SERVICE BULLETIN

#A1-79

SUBJECT: HA-6 Aircraft Carburetor Part No. A10-5206-1

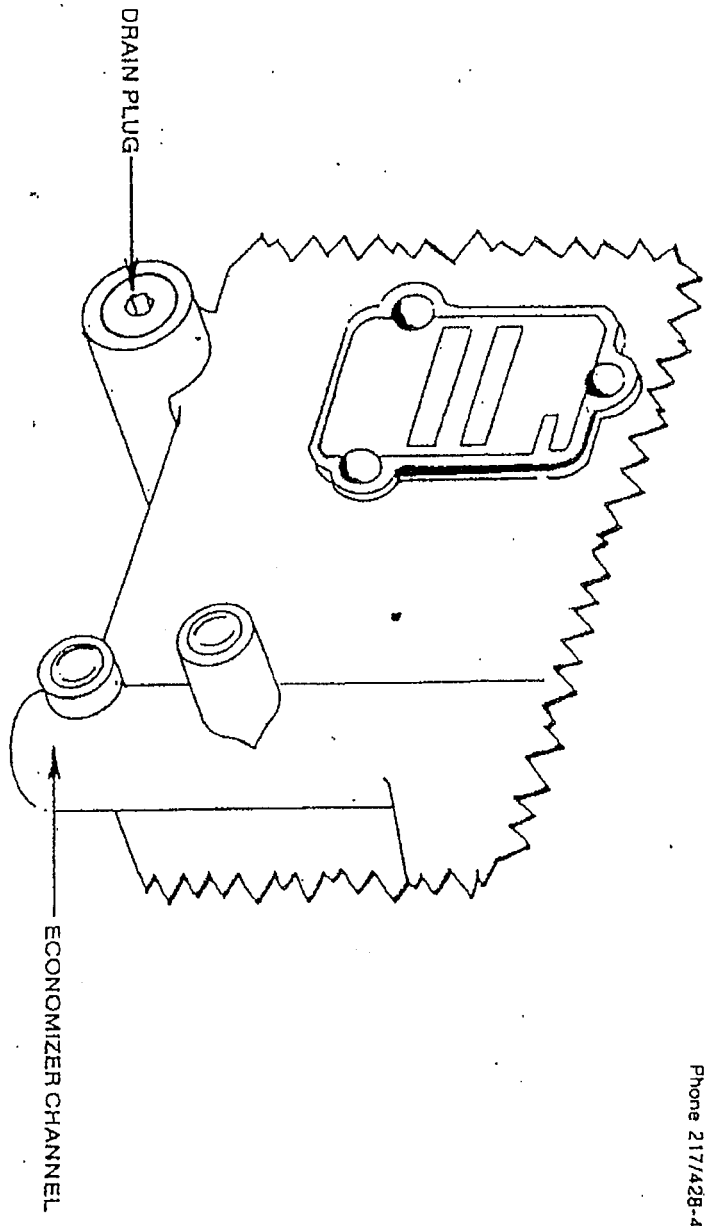
To improve the sealing of the internal economizer channel, remove the economizer channel plug #80-150 and replace it with #80-364 brass plug.

This can be installed with the carburetor on the airplane.
